AGENDA FOR REGULAR MEETING VILLAGE OF TINLEY PARK PLAN COMMISSION

Item #1 WORKSHOP: 7-11 – 171st & HARLEM AVENUE

PLAN COMMISSION STAFF REPORT

Above: Propose Site/Geometric Plan

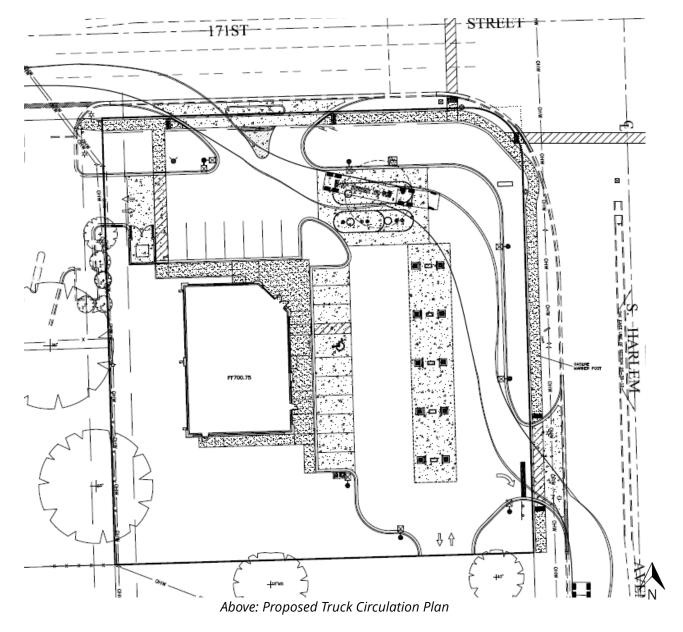
Open Item #2: Discuss Variation to reduce the minimum drive aisle width from 26 feet to 24 feet.

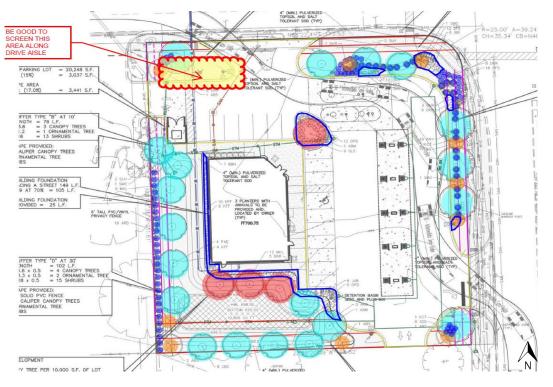
The Village's consultant supports the bufferyard and parkway requests with a couple of recommendations/changes listed below. Staff recommends these few revisions be made to reduce the landscape waivers were possible.

- 1. They have only upsized shade trees to a combination of 3" and 4" cal. It is recommended that all CT trees be increased to a minimum of 4.5" cal.
- 2. Add some shrubs along the north drive aisle in the NW corner of the site to help offset the deficiencies.
- 3. Revise the west bufferyard design to add two additional shrubs.

Open Item #4: Discuss the proposed landscape plan and requested Landscape Ordinance waivers. Discuss staff's recommendations to best offset deficiencies.

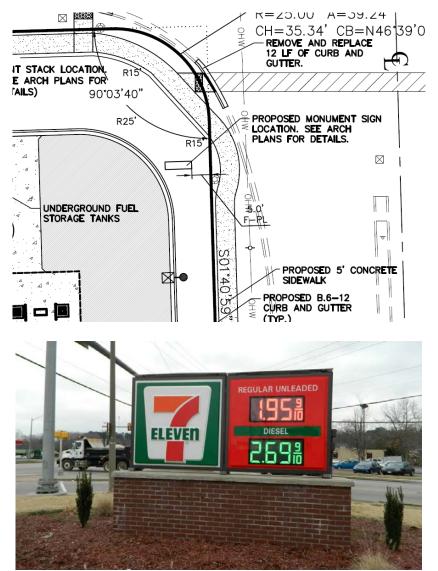
Staff originally recommended a more residential roof for the convenience store building, utilizing more residential elements such as shingles and peaks. However, the architectural design is prototypical of 7-Eleven's new branding initiative. A peak was added to the front entrance and caps to the architectural treatments to give a more traditional look to the building.

Open Item #6: Review the proposed architectural design and materials used throughout the site.

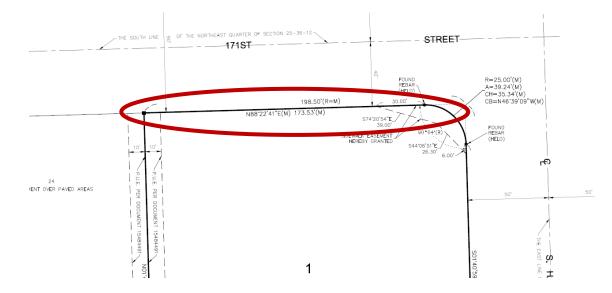
These Variations are the result of their prior use and subdivision as residential lots. The area is shown as a commercial/office use in the Village's Comprehensive Plan (2000). Due to the multiple curb cuts and difficulty of access, residential uses are not considered the highest and best use for this area. Since the 1980s, the lots have been redeveloped in the area with commercial buildings and have been rezoned to either B-1 (Neighborhood Shopping) or B-4 (Office and Service) due to their proximity to the single-family residential to the west. The properties to the south of the subject property have similar lot dimensions as the proposed lot.

Open Item #11: Discuss the requested Variations associated with the lot dimensions and size.
